PHASE II REMEDIAL INVESTIGATION

**INSTALLATION RESTORATION STUDY
NAVAL SUBMARINE BASE - NEW LONDON
GROTON, CONNECTICUT**

RE: Phase II Remedial Investigation
Atlantic Project No.: 1256-18

**NAVY RESPONSES TO EPA COMMENTS (MAY 5, 1993)
ON THE REVISED DRAFT PHASE II
REMEDIAL INVESTIGATION WORK PLAN (MARCH 1993)**

FIGURE 10-1
PROJECT SCHEDULE

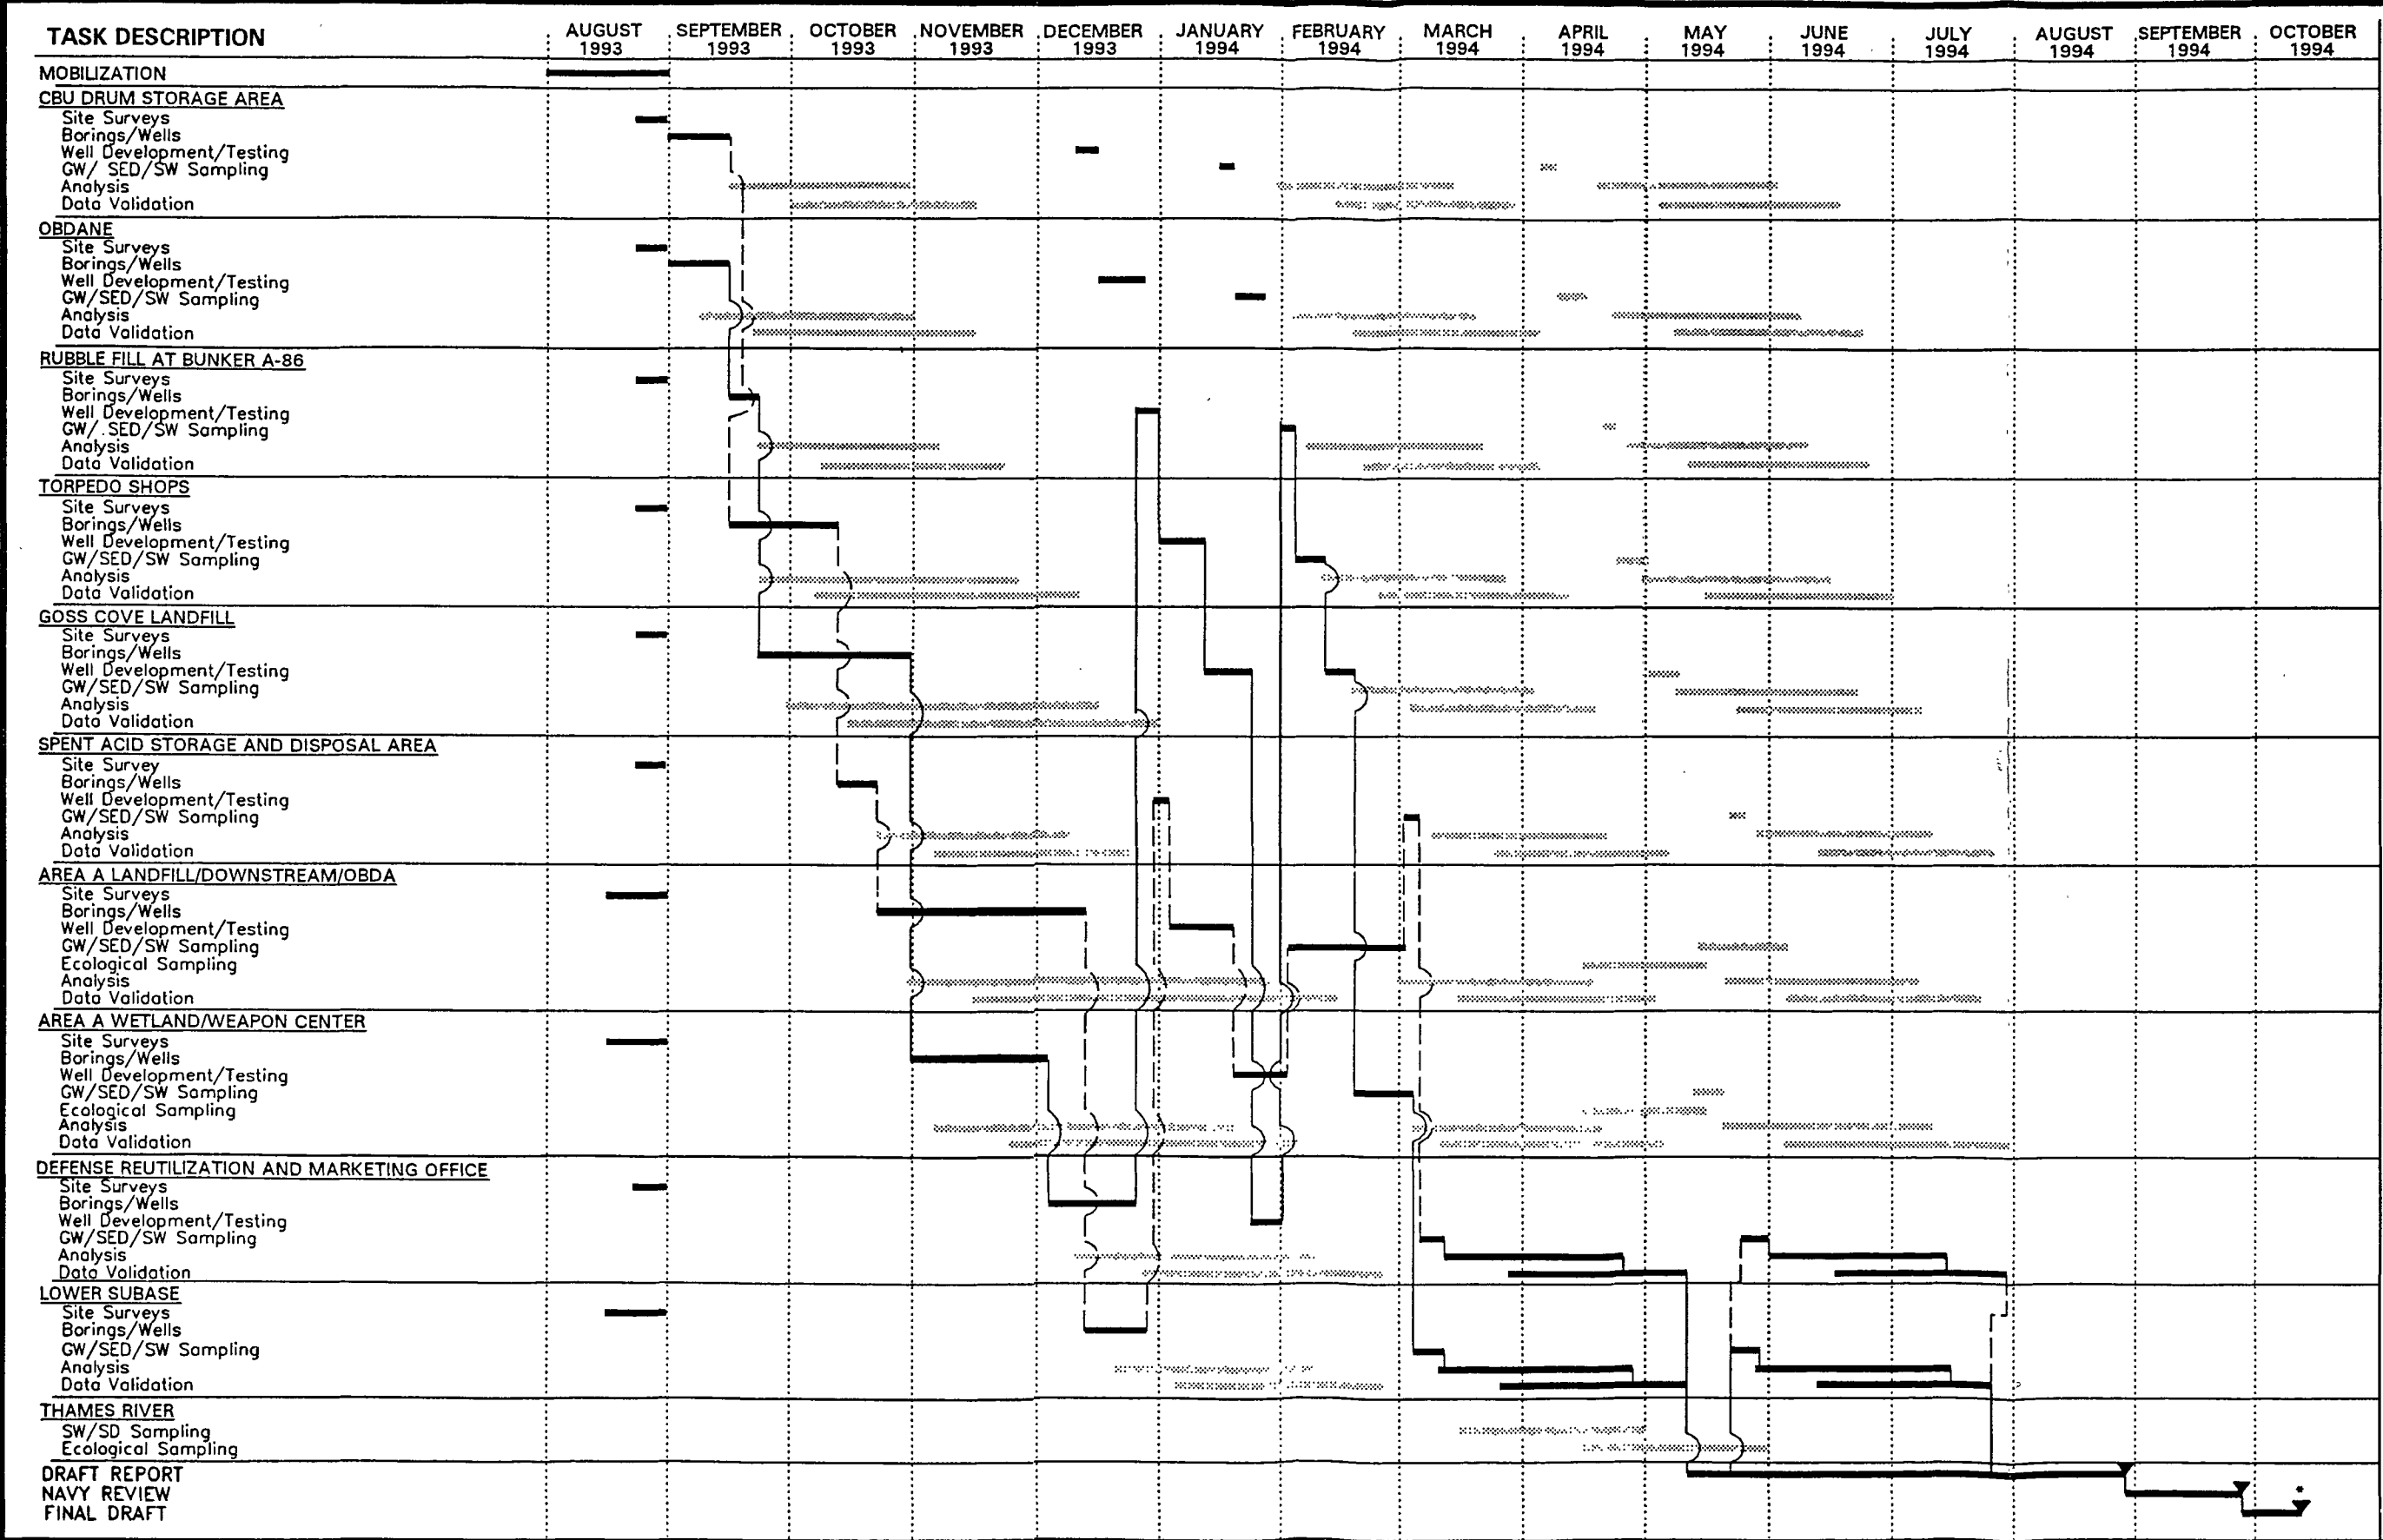
68. **Figure 10-1 - Project Schedule (Page 196)**
